City of Port St. Lucie
Zoning Text Amendment
Project No. P26-020

City Council Meetings of April 27, 2026 and May 11, 2026

Project Summary

Figure 4

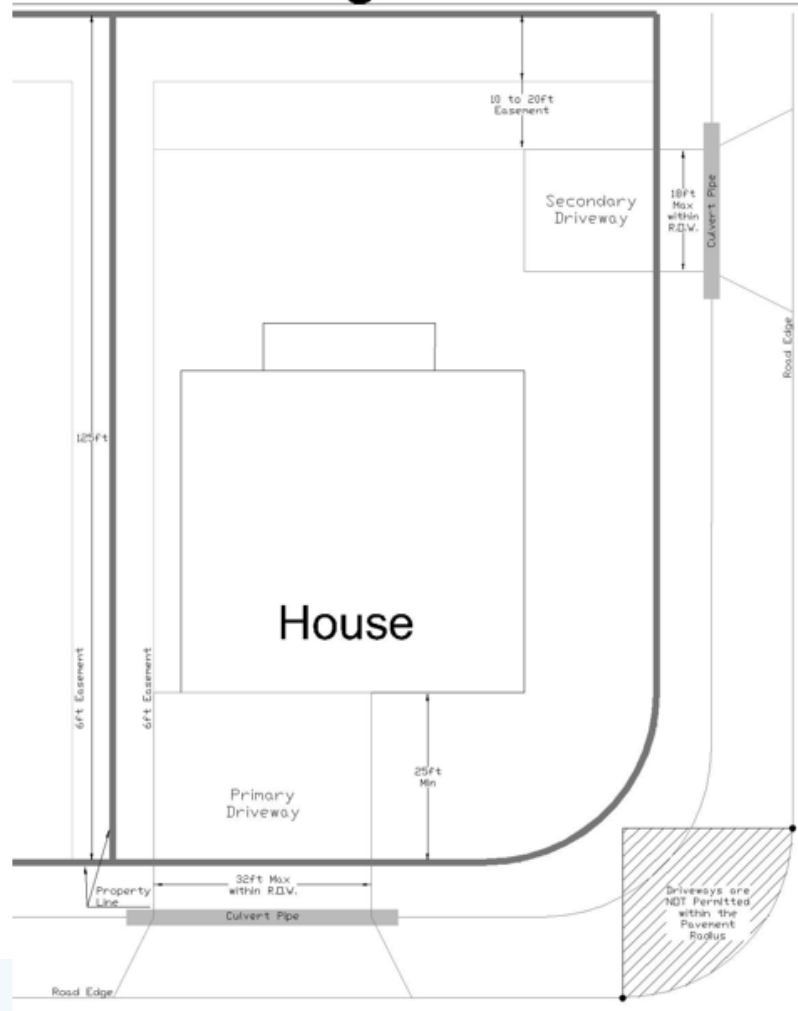
- iii. Secondary driveways on corner lots may consist of unimproved surfaces, such as sod (see Figure 4).
